ADDENDUM NO. 02

January 17, 2020

Murrieta Mesa High School New Classroom Building – DSA 04-118451 MURRIETA VALLEY UNIFIED SCHOOL DISTRICT

Project No. 02132020
DSA No. 04-118451
File No. 33-H18

DRAWING
A5.1
AD2-A05

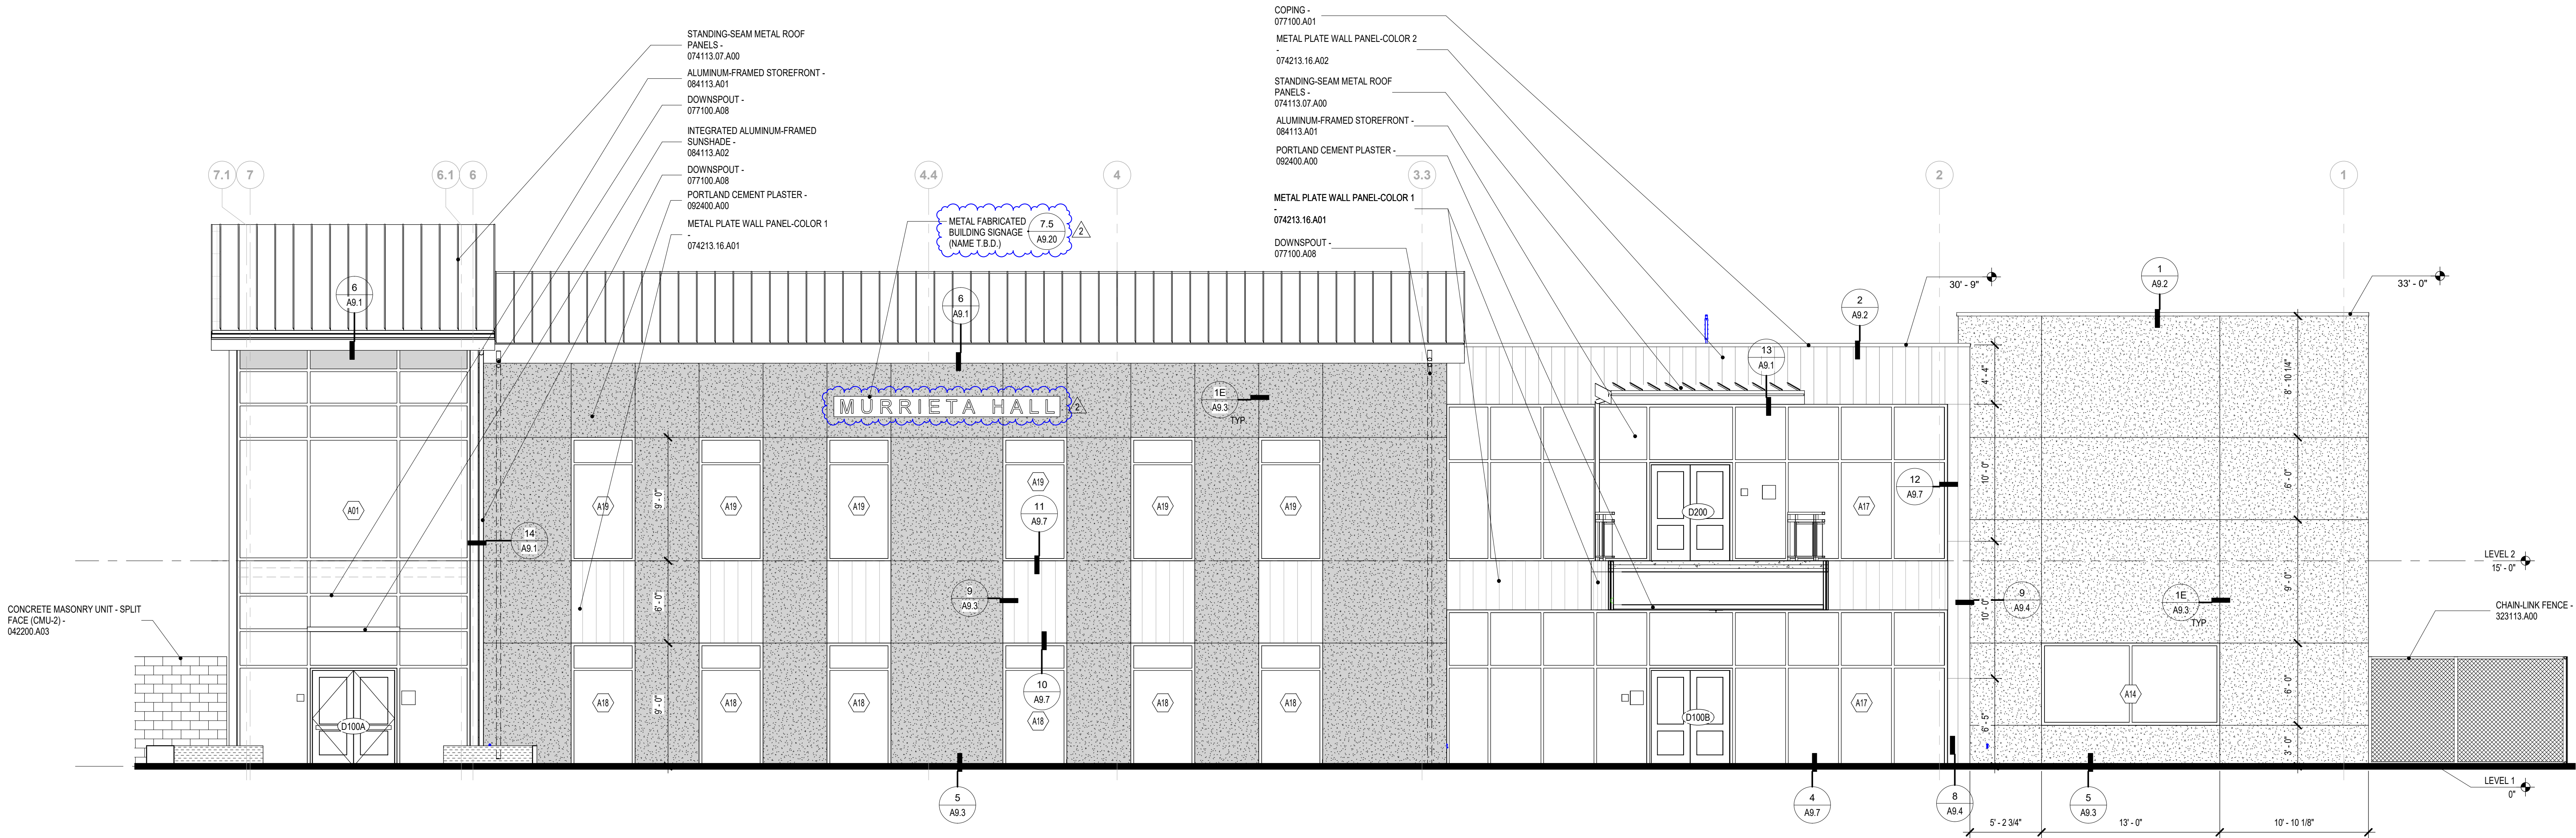
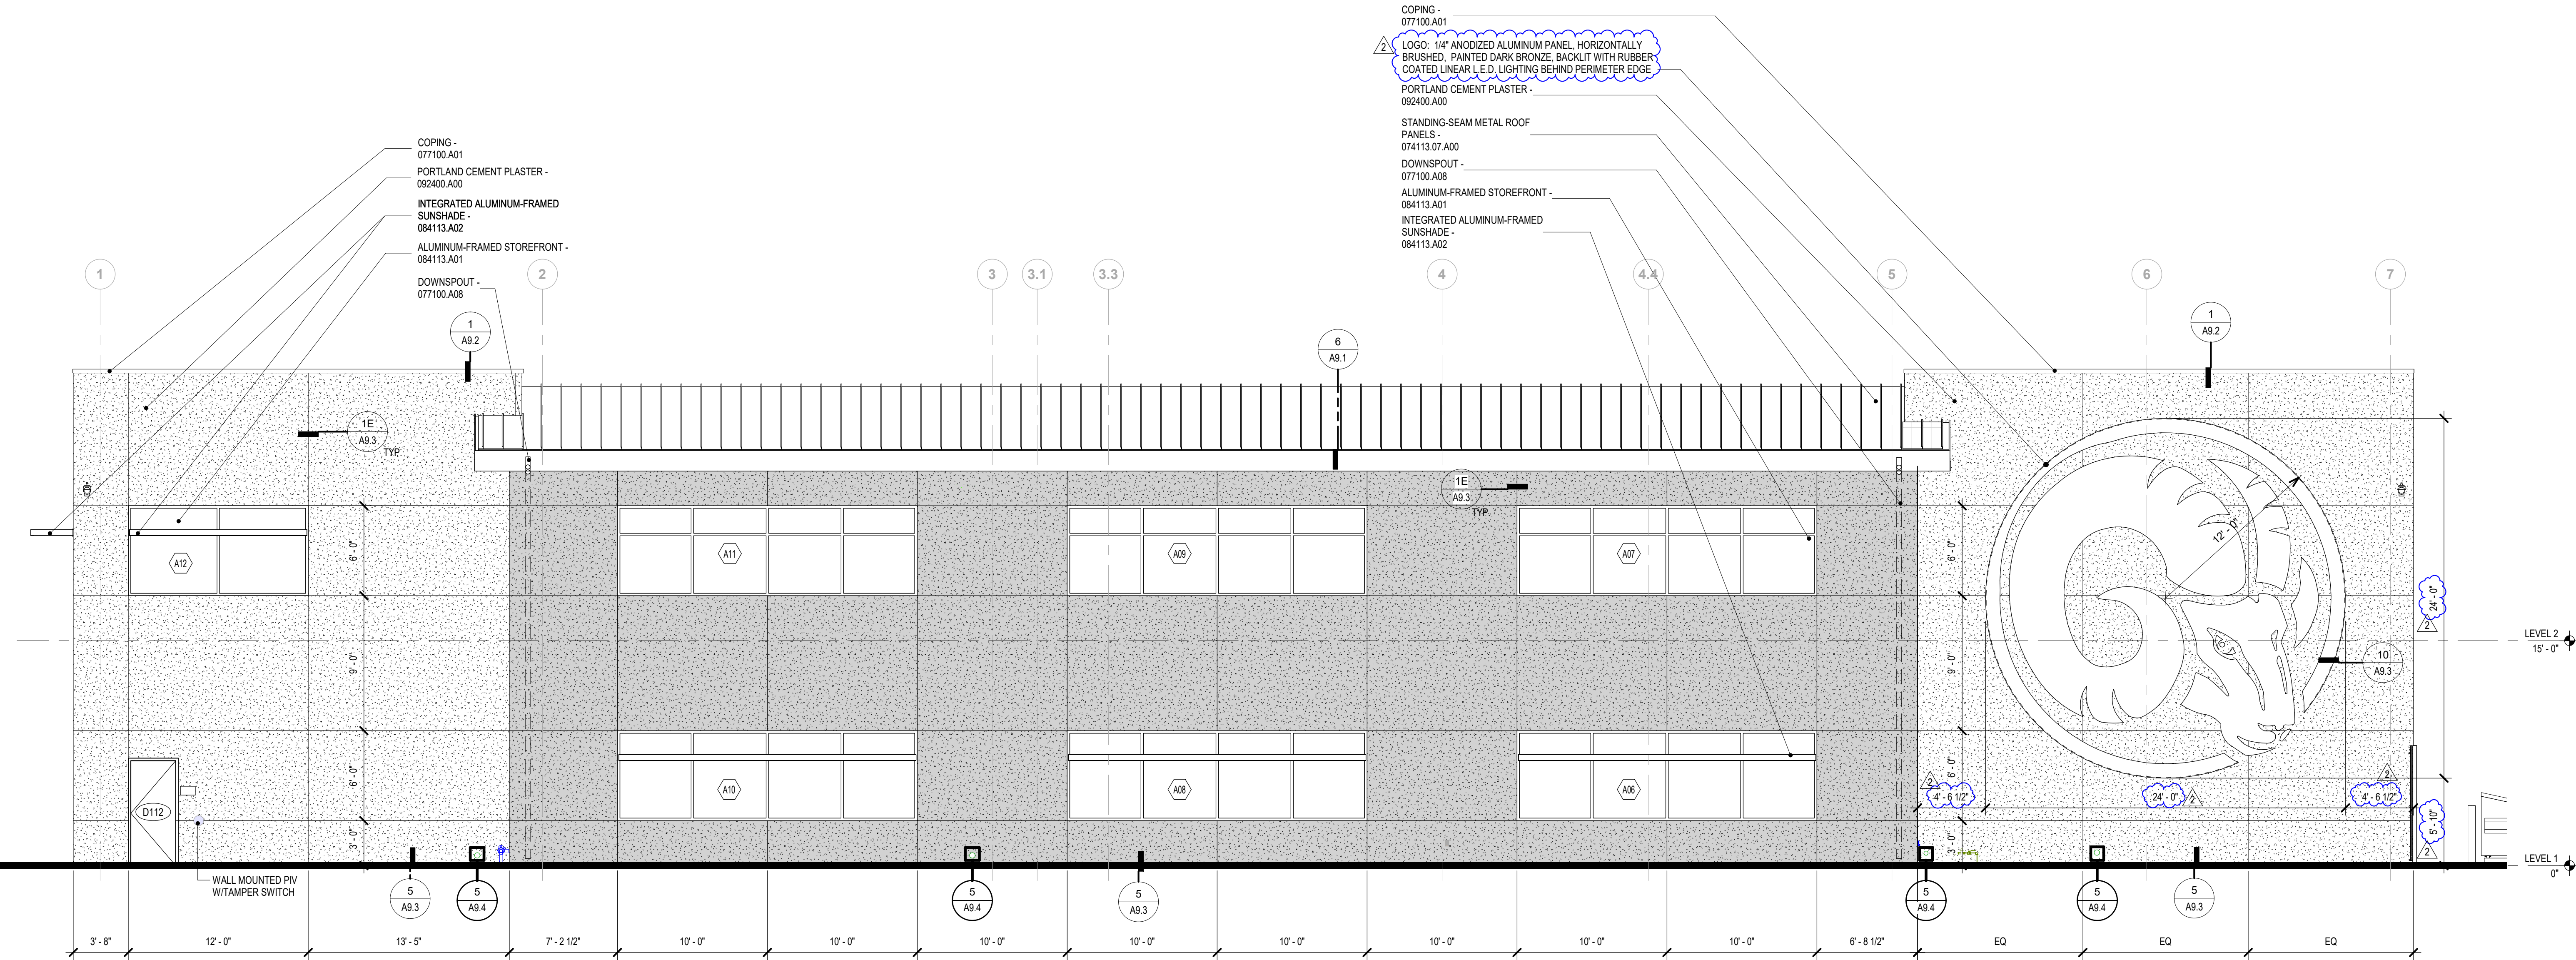
1. Drawing A5.1: Revise currently issued drawing per AD2-A05.
2. Drawing A9.3: Revise currently issued drawing per AD2-A06
3. Drawing A9.20: Revise currently issued drawing per AD2-A07.

10 METAL FABRICATED LOGO MOUNTING DETAIL
A5.1 3" = 1'-0"

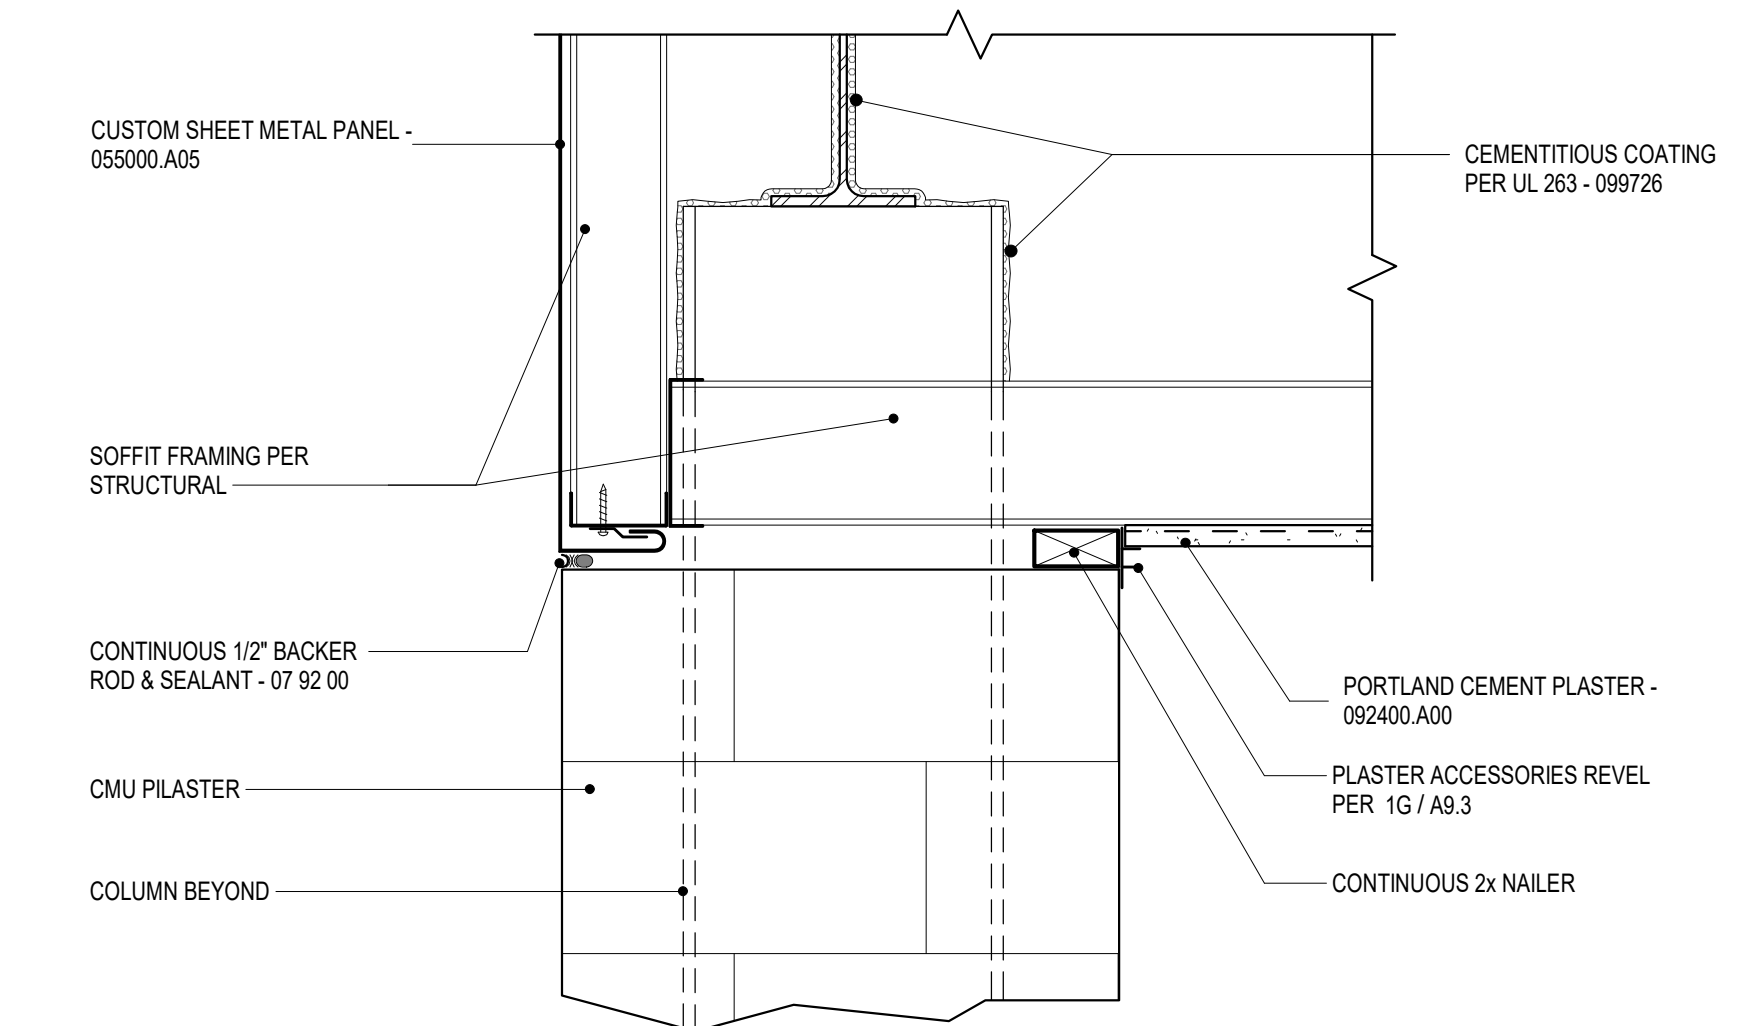
1. Building Logo calls for a 1/4" anodized aluminum panel, painted dark bronze; however, there's no specification for Dark Bronze Paint. Please note that the dimensional letter signage specification appears to call for anodized aluminum lettering with integral color, not paint.
2. Building signage Detail 7.5/A9.20 per AD2-A07 calls for a painted copper penny. Please advise if this is the intended color and provide specification.
3. The metal plate at stanchion on Detail 11/A9.20 per AD2-A07 doesn't call for paint, but stanchion does. Please review and advise.

1. Building logo and building name signage are both entirely custom. Colors noted on the details from Addendum 2 are the ones used on the existing signage that already occur around the campus, the fabricator is to match these colors.
2. Specification section 10419 *Dimensional Letter Signage* will be omitted in upcoming Addendum 4 as the lettering will be custom.
3. The metal plate and stanchion shall be painted to match the color of the surface it is mounted to.

DRAWING
M2.2
AD2-M03

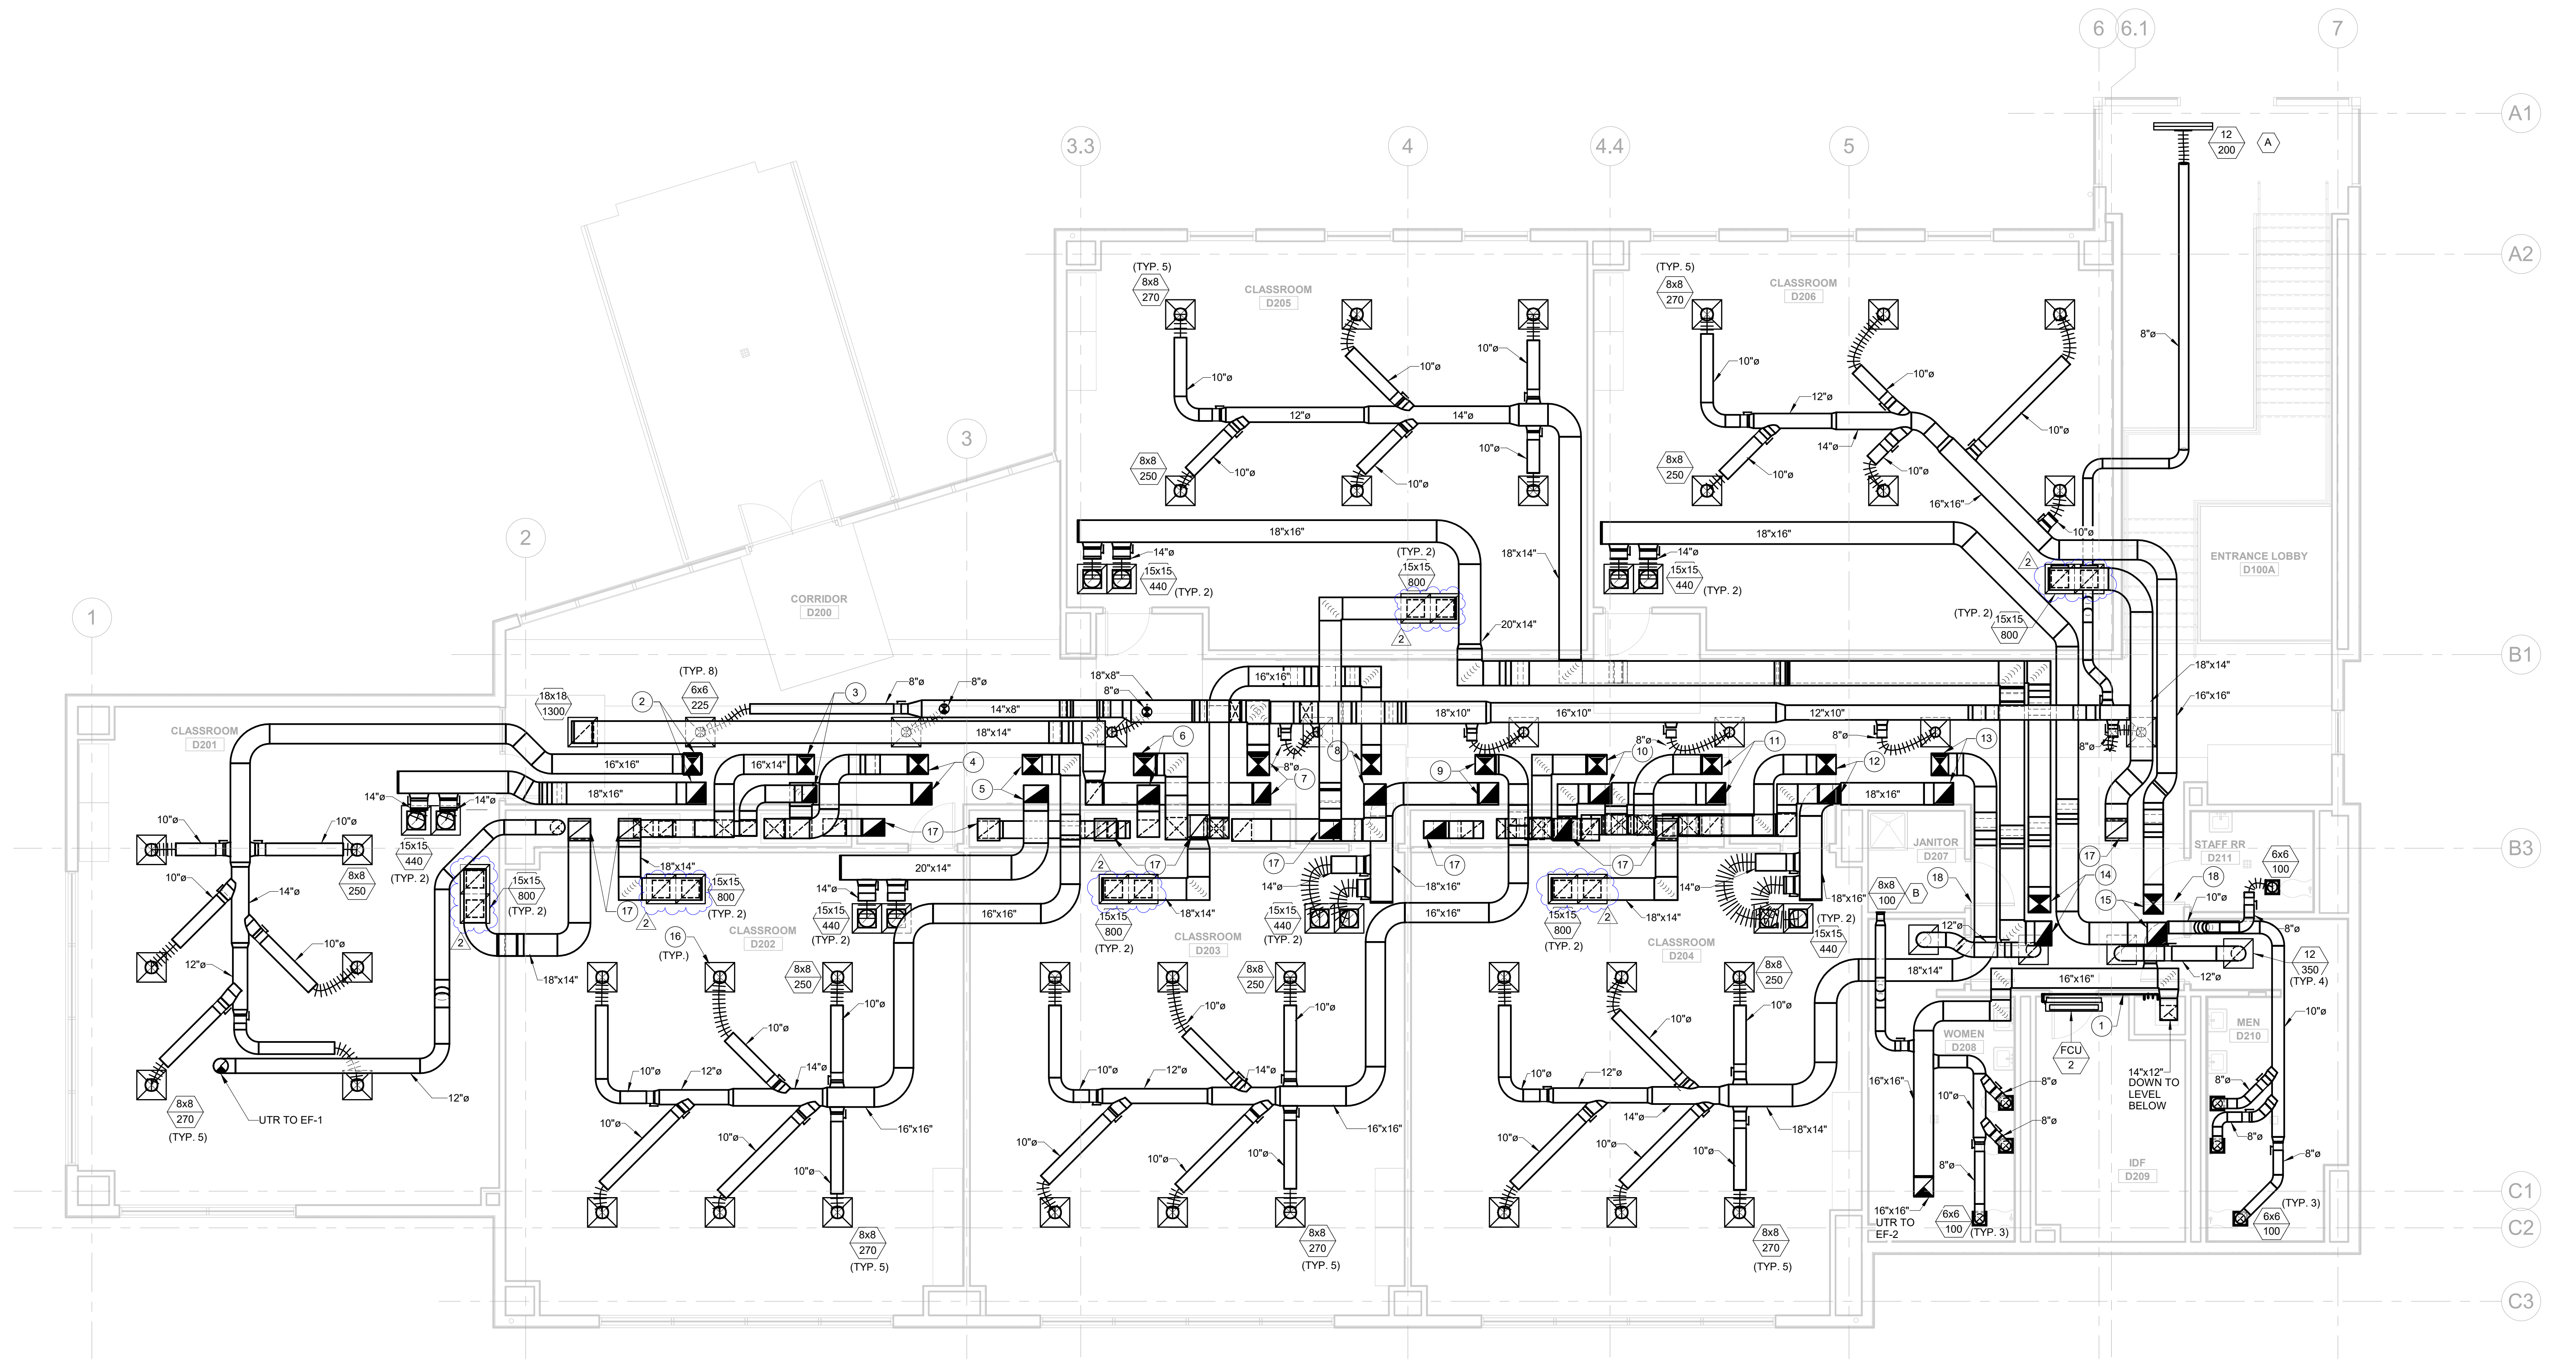
1. Drawing M0.5: Revise currently issued drawing per AD2-M01.
2. Drawing M2.1: Revise currently issued drawing per AD2-M02.
3. Drawing M2.2: Revise currently issued drawing per AD2-M03.
4. Drawing M6.1: Revise currently issued drawing per AD2-M04.

BUILDING LETTERING "

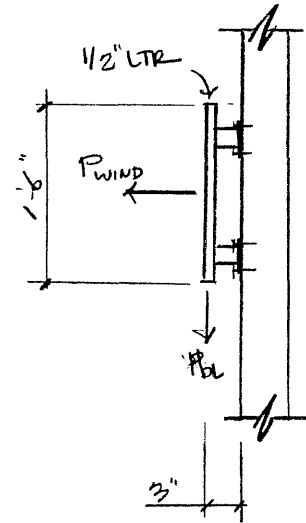
1. Building Lettering
2. Building Logo

PROVIDE (2) #10 SMS T & B
 @ 4'-0" O.C. MAX
